# IMMINGHAM EASTERN RO-RO TERMINAL

Applicant's Response to the ExA's  
First Written Questions

Deadline 2, Date: 5 September 2023  
Document Reference: 10.2.21

**Appendix 2 – Disaggregated AIS Data for the Port of Immingham SHA and the IOT**

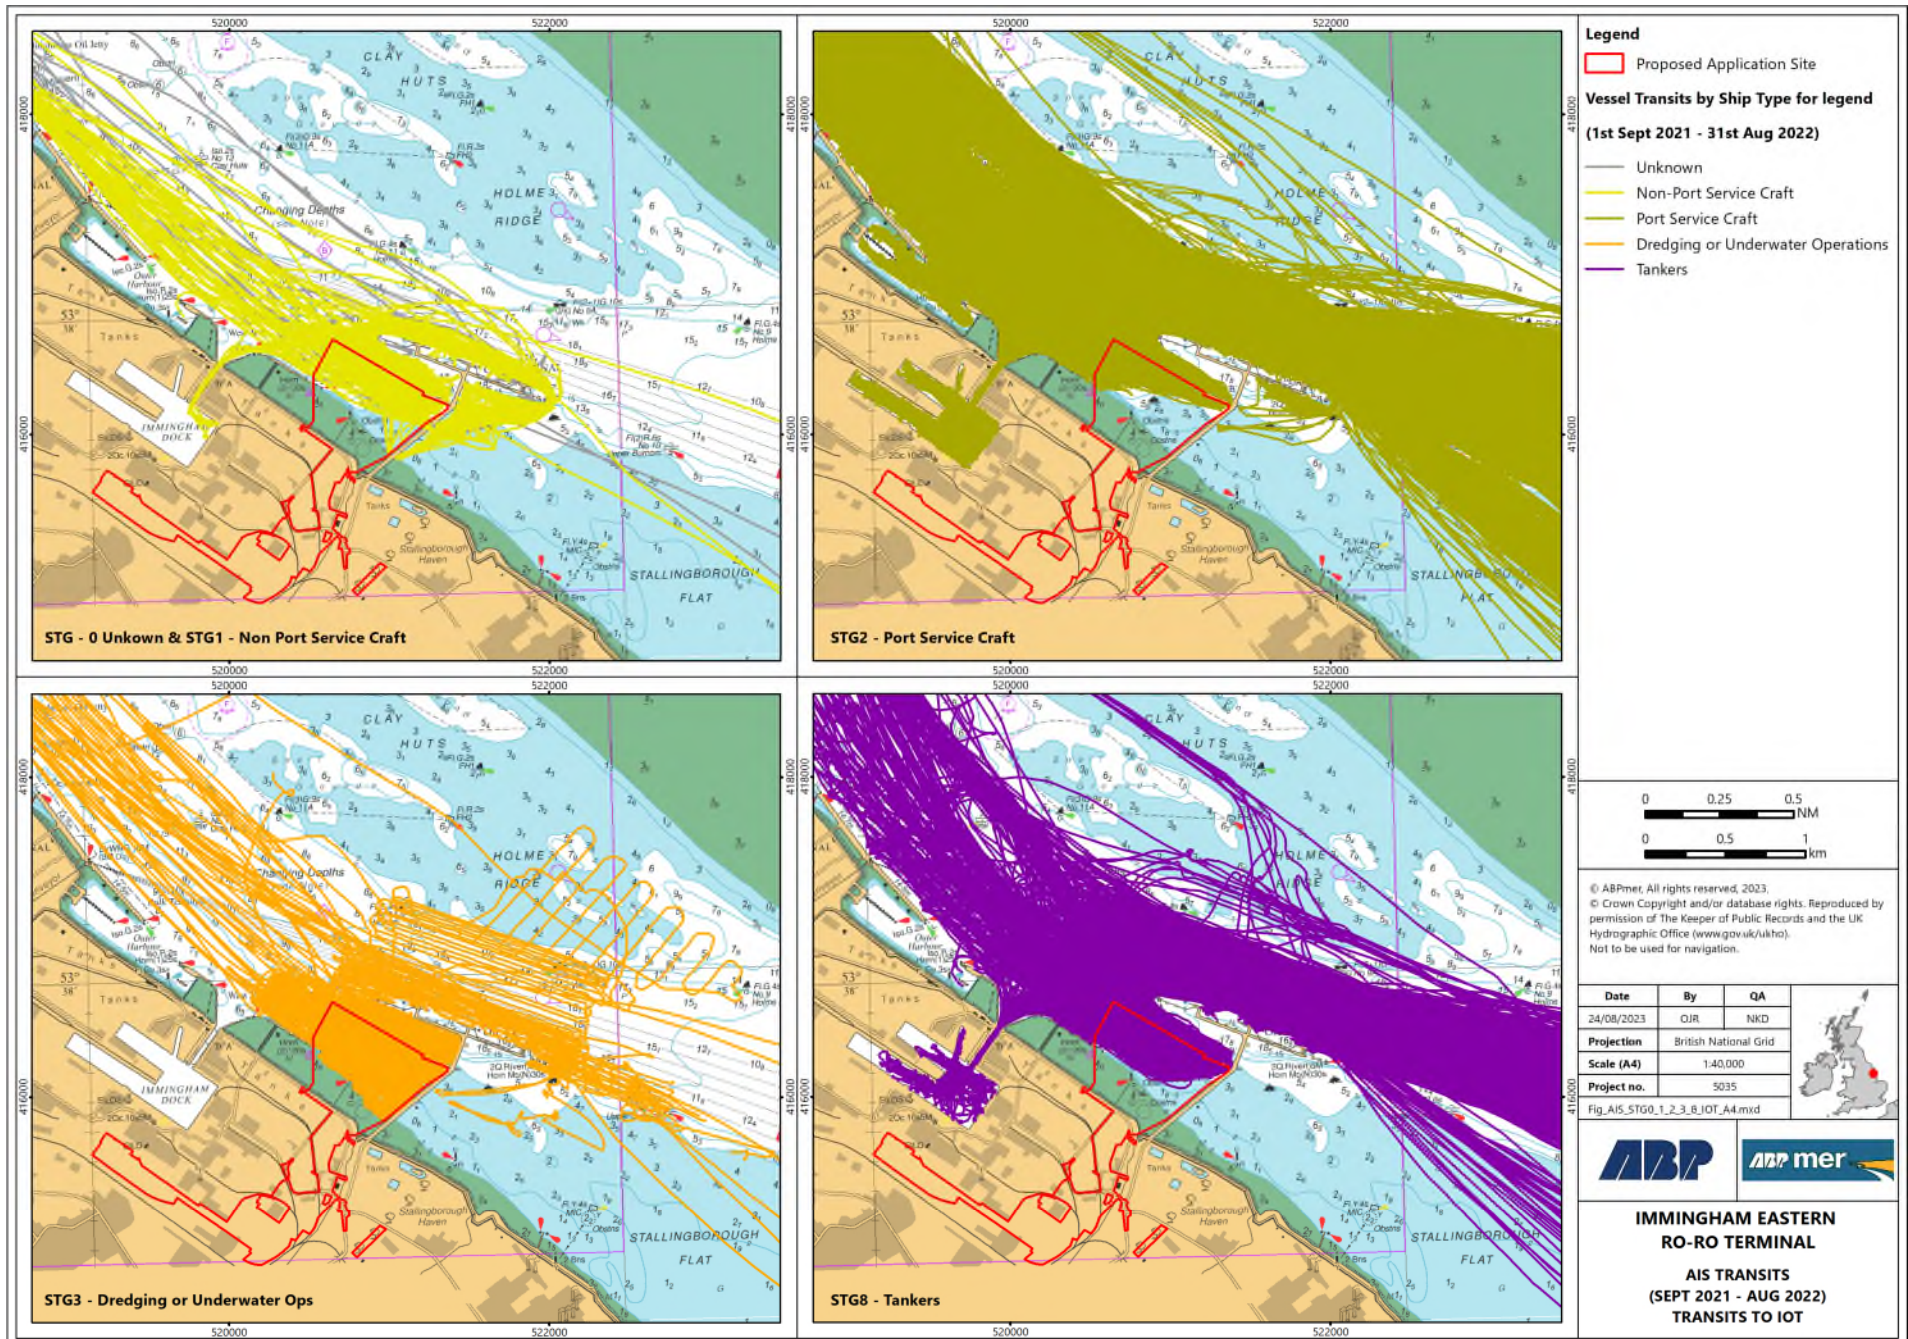
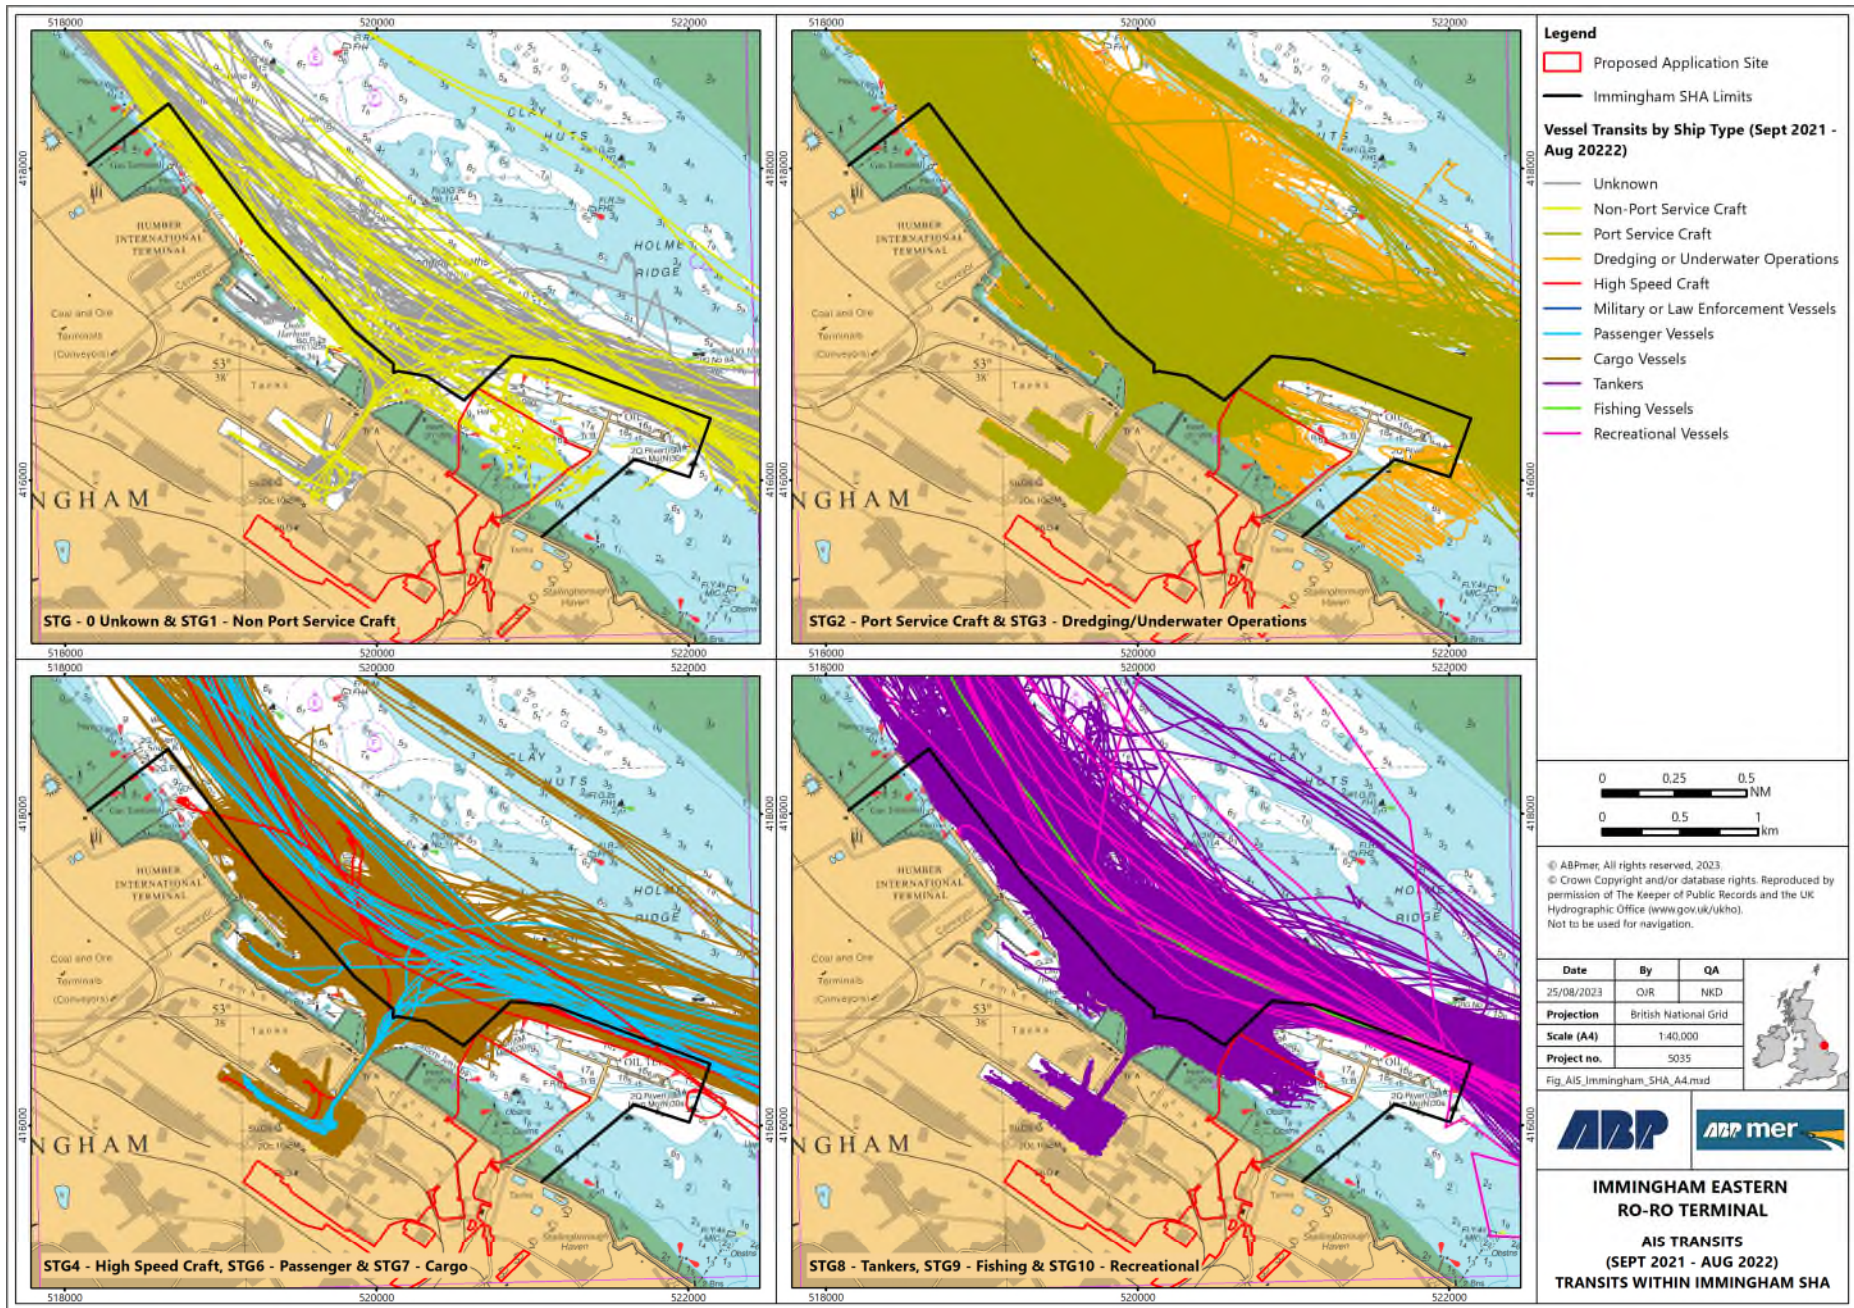
ExQ1	Question to:	Question	Applicant's Response
NS.125	Applicant	<p><b>AIS transit density data</b></p> <p>Explain the "AIS Transect" pecked line in Figure 10.2 of [APP-066] and provide AIS transit plots on a disaggregated basis for: 1) the IOT and 2) the rest of the Port of Immingham for the same time period as depicted in Figure 10.2.</p>	<p>The AIS transect line is the point at which the AIS data is measured to provide the information contained within Table 10.4 and Table 10.5 of Chapter 10: Commercial and Recreational Navigation [APP-046].</p> <p>The figures provided in <b>Appendix 2</b> to this document display disaggregated AIS data for the IOT and the remainder of the Port of Immingham SHA (excluding the IOT) on a per vessel type basis</p>
NS.126	Applicant	<p><b>For Port of Immingham additional predicted vessel movements</b></p> <p>In terms of vessel movements to and from the Port of Immingham, for a typical week provide a summary of the existing vessel arrivals and departures and to that arrival and departure information add the vessel movements predicted to be generated by the Proposed Development.</p>	<p>Taking into account data from January 2022 to end of August 2023, the weekly average vessel arrivals and departures to/from the Port of Immingham total 199 movements. This only considers commercial vessels arriving or departing berths within the Port of Immingham jurisdiction and does not take account of vessels transiting to other ports or terminals within the Humber Estuary.</p> <p>As noted in the Applicant's response to ISH2 Action Point 2 [REP1-009], the marine activity recorded during the Familiarisation Site Inspection on 26 July was confirmed to represent a typical day. Therefore, the Applicant has undertaken an analysis of the Port of Immingham vessel arrivals and departures for the week of 24 July 2023 for consistency.</p>

ExQ1	Question to:	Question	Applicant's Response
			<p>Vessel movements during this period for the Port of Immingham total 192. The IERRT development will generate 42 additional vessel movements per week (i.e., 3 arrivals and 3 departures per day). Based on the above period the total weekly movements for the Port of Immingham including the IERRT vessels will be 234.</p> <p>In the context of the above, however, it should be noted that Stena already currently operate one service from the Port of Immingham which calls at a berth in-dock. As a consequence, once the proposed development is operational, the net increase in Stena's operations will be 4 movements per day, or 28 movements per week. When added to the Port of Immingham weekly vessel movements, this totals 220 movements. The Applicant can confirm this is below peak vessel movements recorded within the Port of Immingham in the last 18 months.</p>

## **Appendix 5 – Internal Routing**

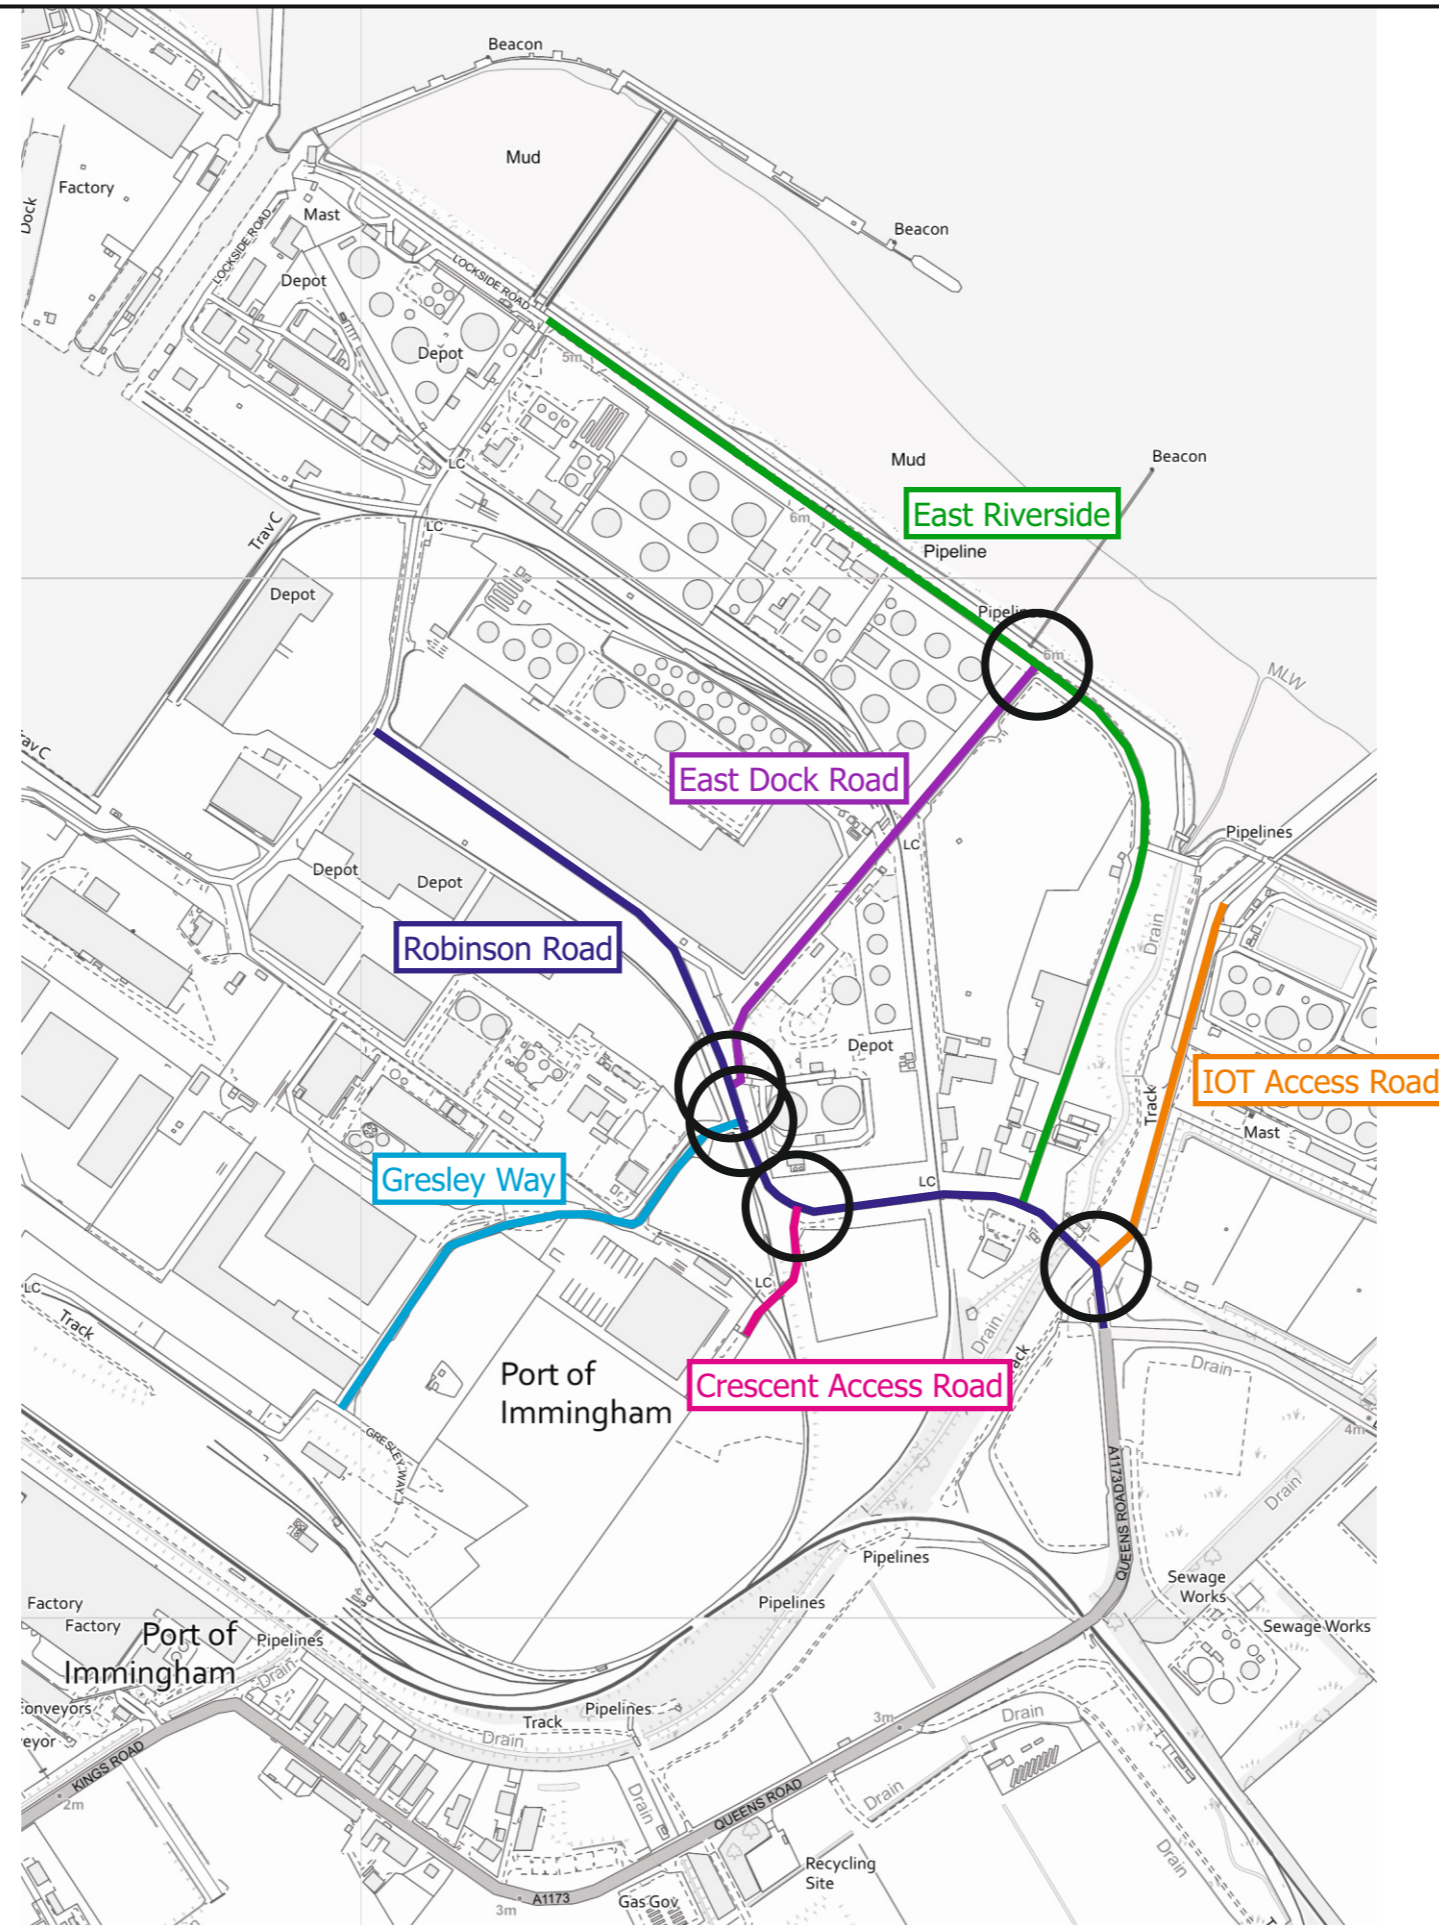
management arising will take place as part of the Section 278 design process.
TT.14	Applicant	<p><b>Internal port traffic movements</b></p> <p>Indicate on a plan or plans the likely internal roads between the East Gate and the West Gate that might be used by vehicles during the construction and operational phases.</p>	<p><b>Appendix 5</b> to this document shows the routes which vehicles would take from each security gate through the port.</p> <p>The route from the site to East Gate is around 400m in length.</p> <p>The route to West Gate is a distance of some 3.5km and involves routing through one priority junction, a signal controlled crossing and two roundabouts.</p> <p>As set out in the CEMP [<b>APP-111 Plate 1</b>], all construction traffic movements will be routed via East Gate.</p>
TT.15	Applicant	<p><b>Capacity analysis of road junctions within the port</b></p> <p>Signpost any capacity analysis for the Port of Immingham internal road junctions that has been undertaken. If such an analysis has not been undertaken explain why that is?</p>	<p>Capacity assessments of internal junctions can be seen in <b>Annex M (Technical Note 4) of the TA [AS-008]</b>. The internal junctions within the statutory port estate which were assessed were:</p> <ul style="list-style-type: none"> <li>Robinson Road/ Crescent Access Road Junction;</li> <li>East Riverside/ East Dock Road;</li> <li>Robinson Road/ East Dock Road;</li> <li>Robinson Road/ Gresley Way;</li> <li>Robinson Road/ East Riverside; and</li> <li>Robinson Road/ IOT Access Road.</li> </ul> <p>These junctions can be seen in <b>Appendix 6</b> to this document. They were assessed because they are the junctions immediately affected by part of East Riverside being closed as part of the proposals.</p> <p>The junctions which will accommodate the traffic to and from the proposed development between the site access and West Gate</p>
